Re: DA 0453/12 - SPD Residential (JRPP Reference: 2013SYW023) and DA 0053/13 - SPD Commercial (2013SYW034)

I refer to the decision of the Joint Regional Planning Panel on 16 June, 2015 with respect to the abovementioned Development Applications, and herewith provide our response to matters raised on behalf of our client, the Seventh Day Adventist Church (South Pacific Division).

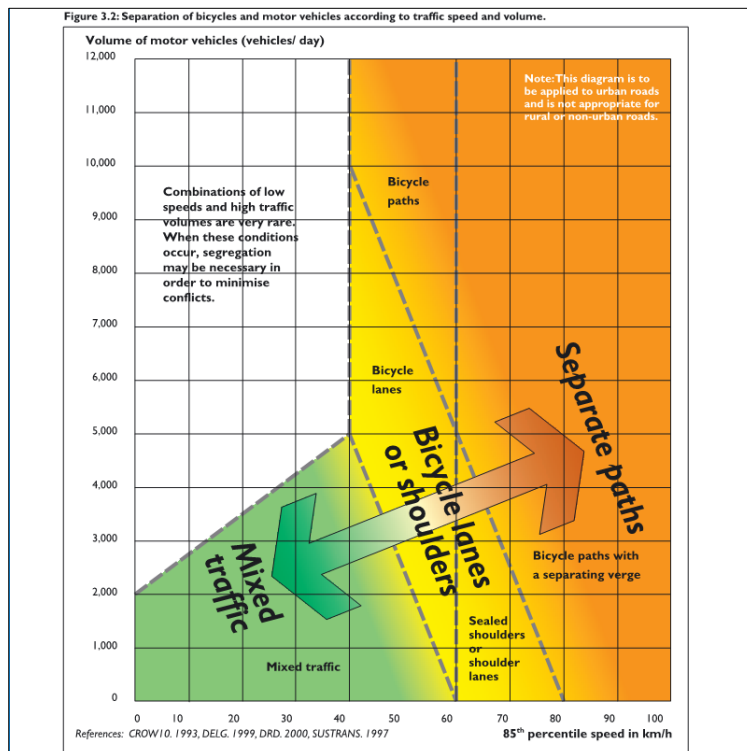
It is our client's intention to incorporate a shared vehicle/bicycle network on the internal (non-public) hospital road, consistent with the original strategy of the Concept Plan approval. Austroads standards enable shared (mixed traffic) roads as detailed in table below.

The volume of motor vehicles on the shared road portion is less than 2,000 per day with the speed limit of the internal access road already set and signposted at 10km/h.

Our client is willing to accept a condition that requires that sufficient allocation of space and line-marking of the shared bicycle network be undertaken as part of this DA.
